A REPAIR

SEWAGE DISPOSAL SYSTEM

HOWARD COUNTY
BUREAU OF ENVIRONMENTAL HEALTH
461-9933

PROPERTY OWNER Spencer Arrington

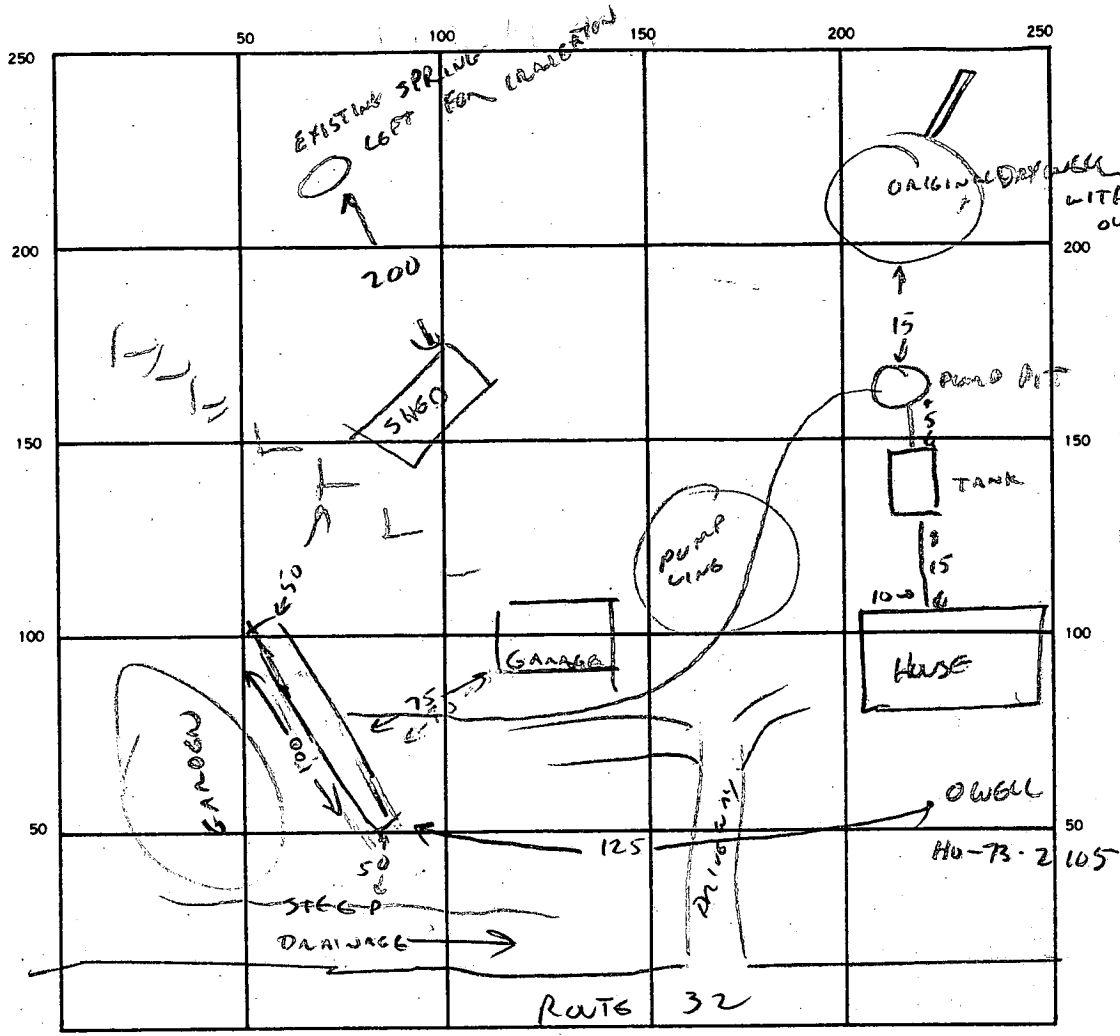
REMARKS 3/28/88 TRENCH & TANK OK TO COVER.

SEWER PUMP LINES NOT YET IN. CALL WHEN PUMP INSTALLED. CU)

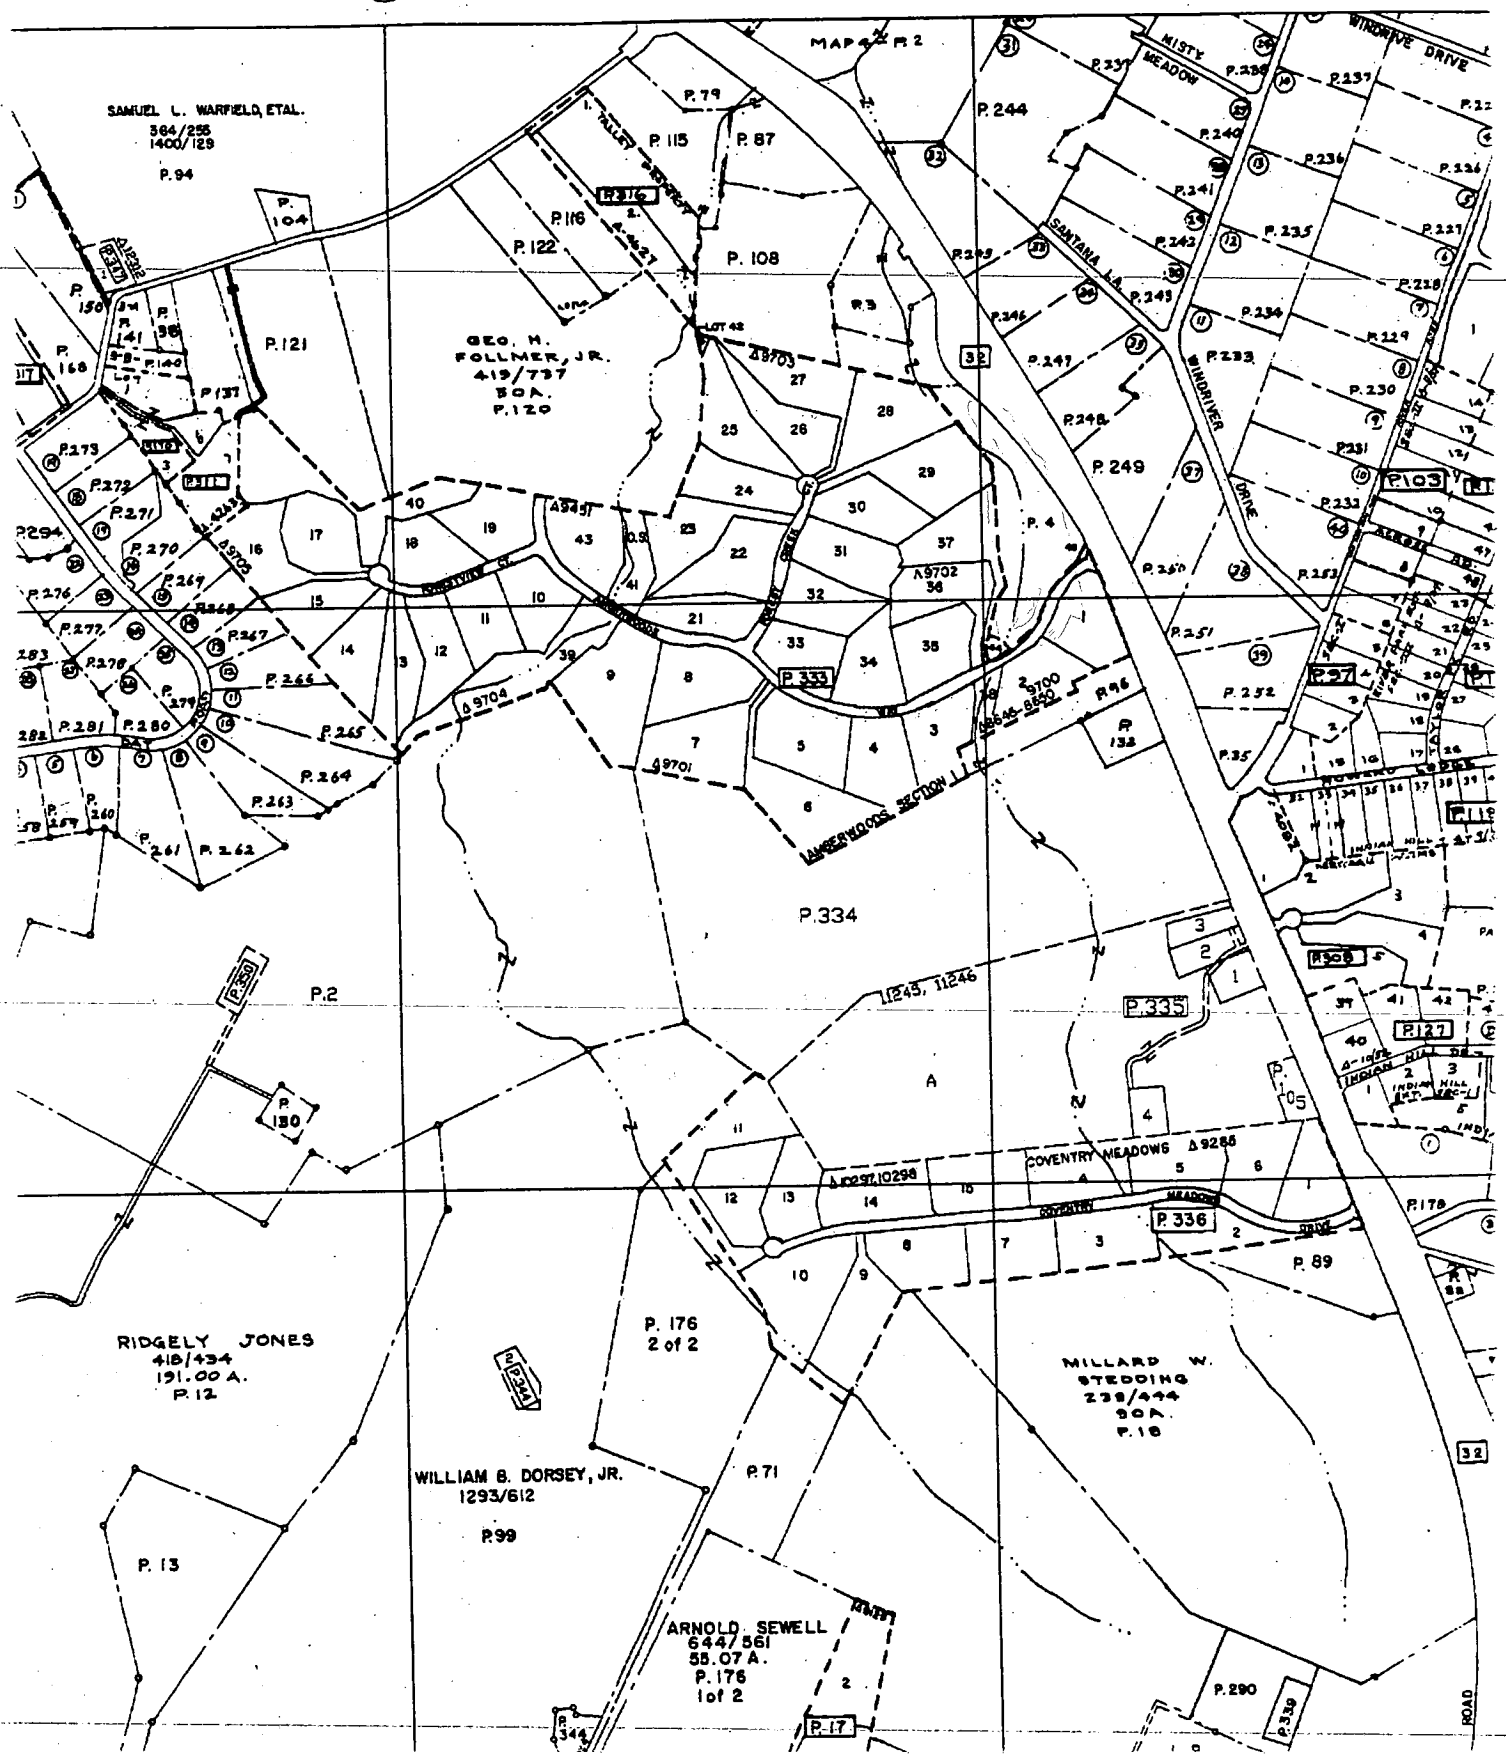
REASONS FOR REJECTION OR HOLDING 6-30-87 Perc Satisfactory - Hold for PLAT. Repair of
existing syst. to be on pumps. S. Alan

Holes
6-8
Shift
TOWARD
BACK OF LOT FROM
SOIL PROFILE DRAWING

REMARKS Pump syst required for existing house

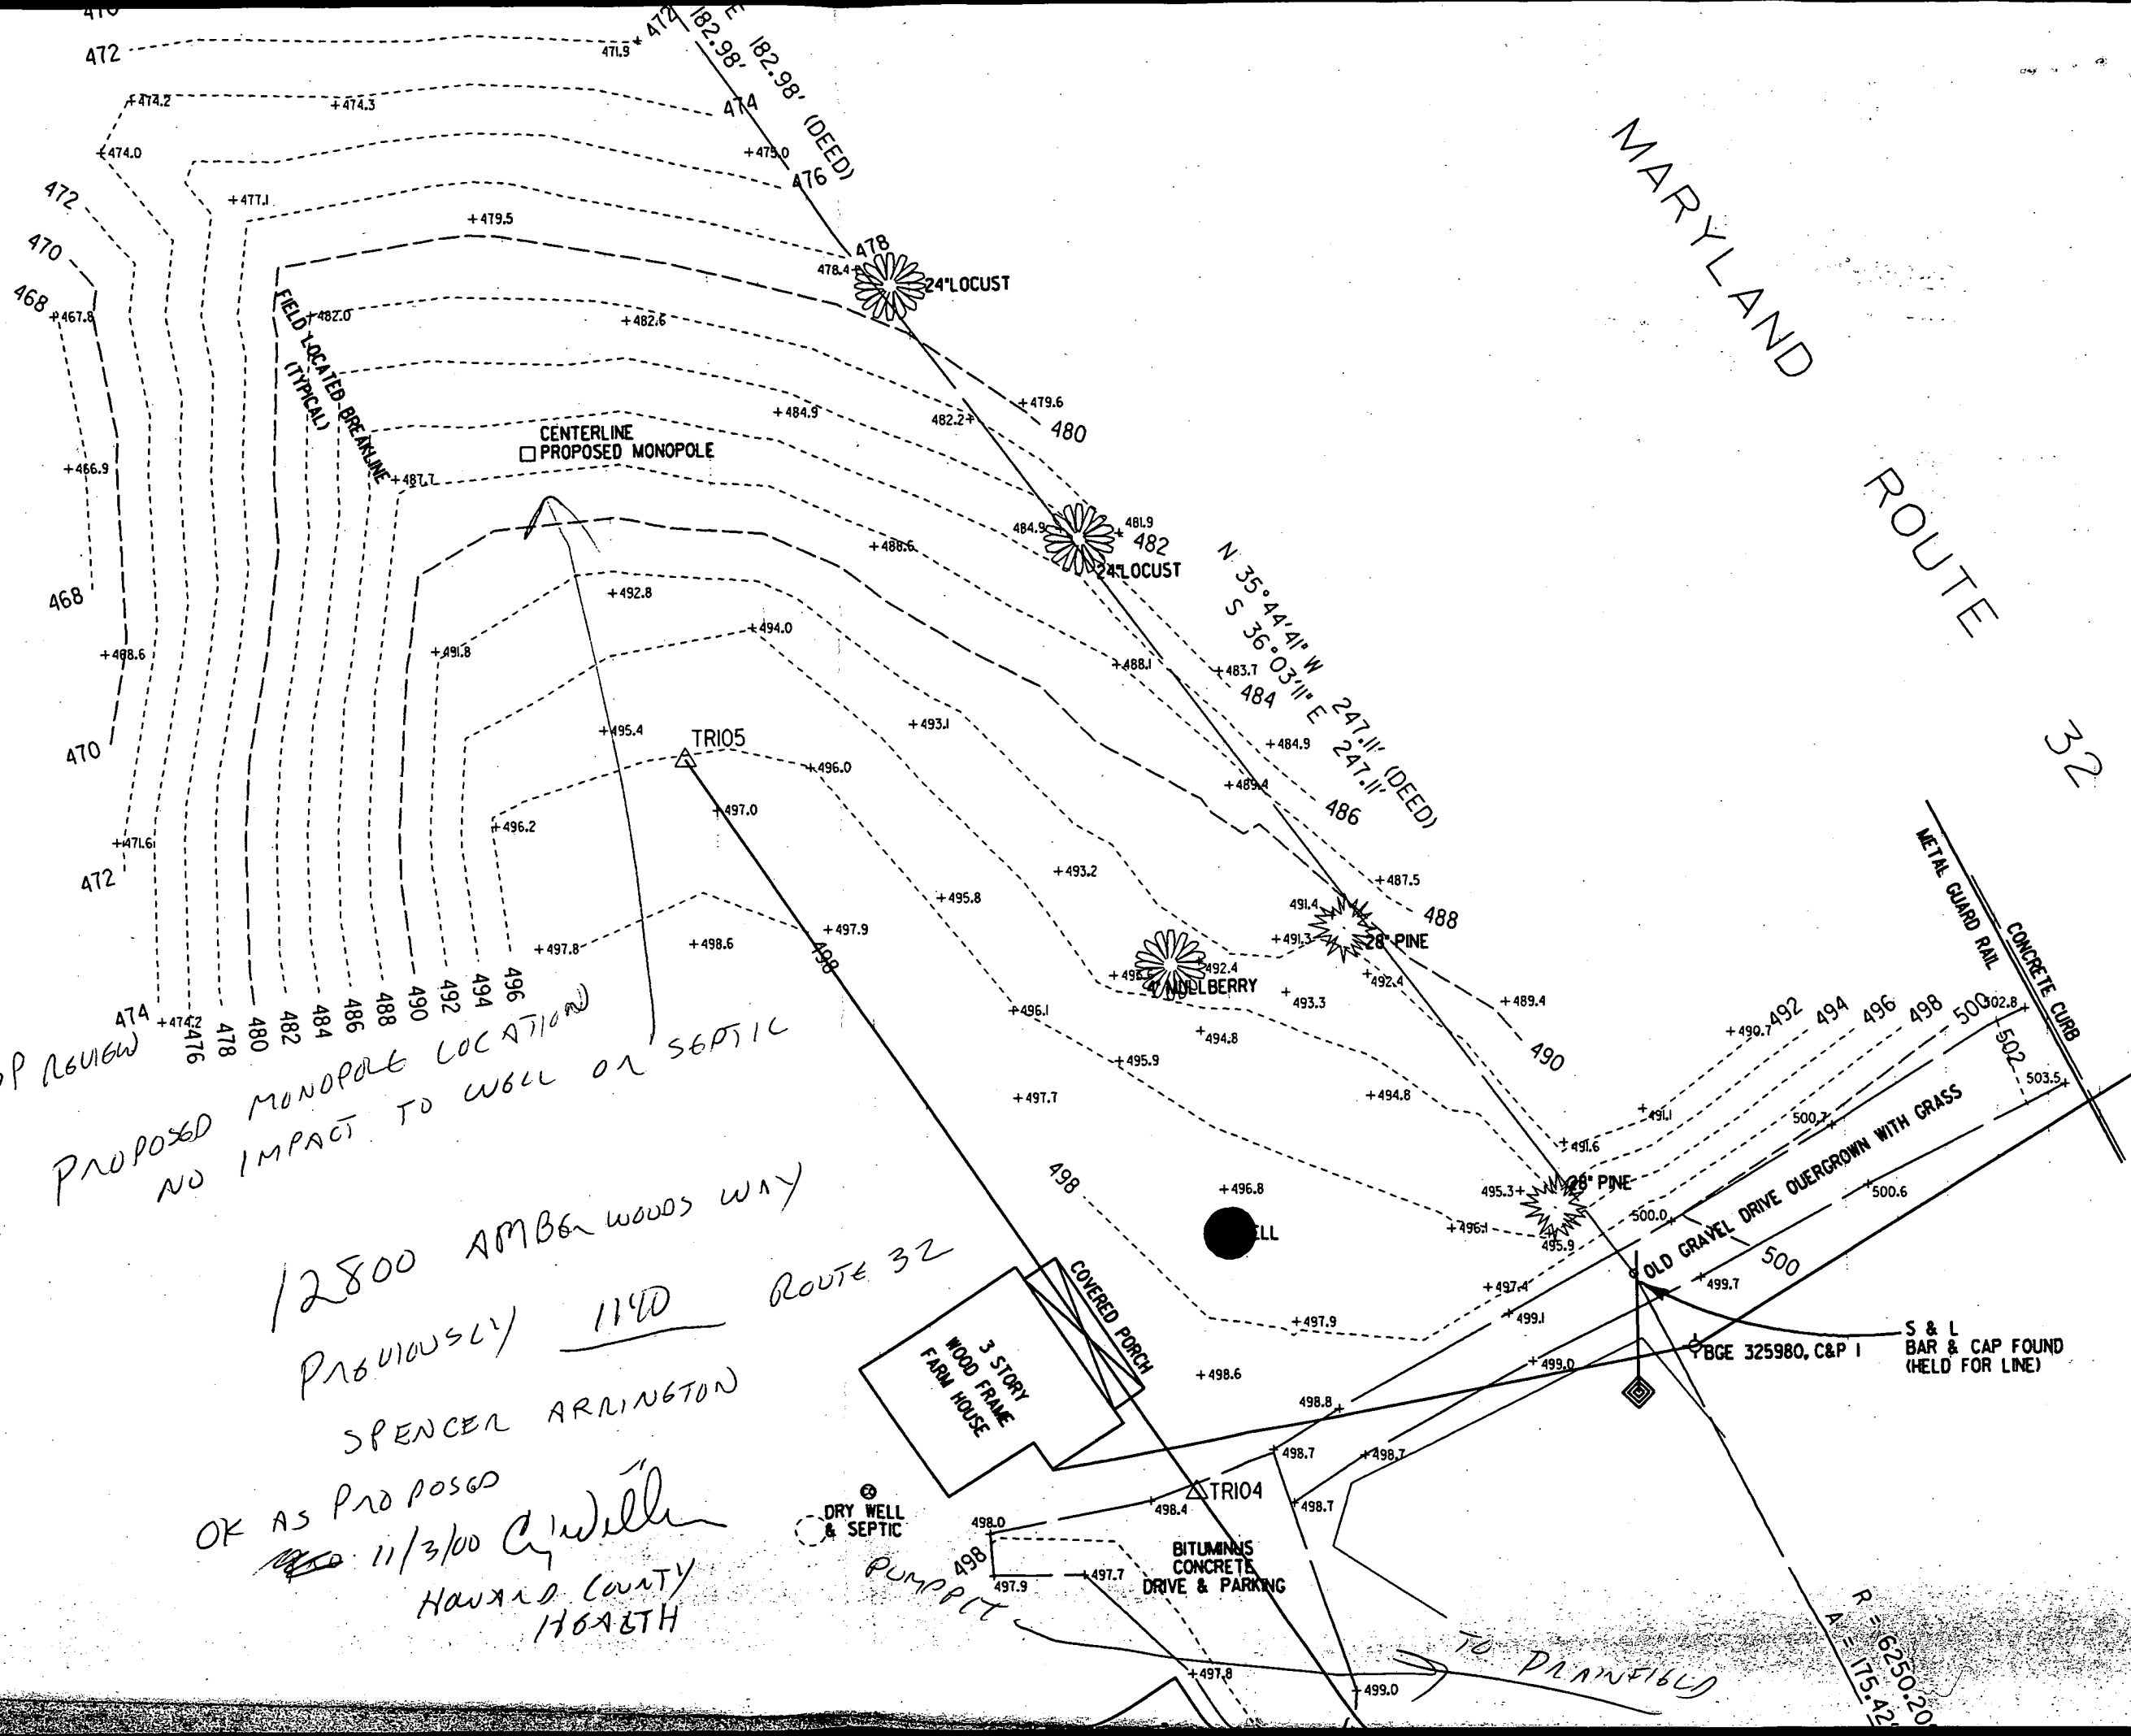
PROPOSED MONOPOLE LOCATION
NO IMPACT TO WELL OR SEPTIC

12800 AMBER WOODS WAY
PREVIOUSLY 1140
SPENCER ARRINGTON
OK AS PROPOSED
11/3/00
HARRIS COUNTY HEALTH
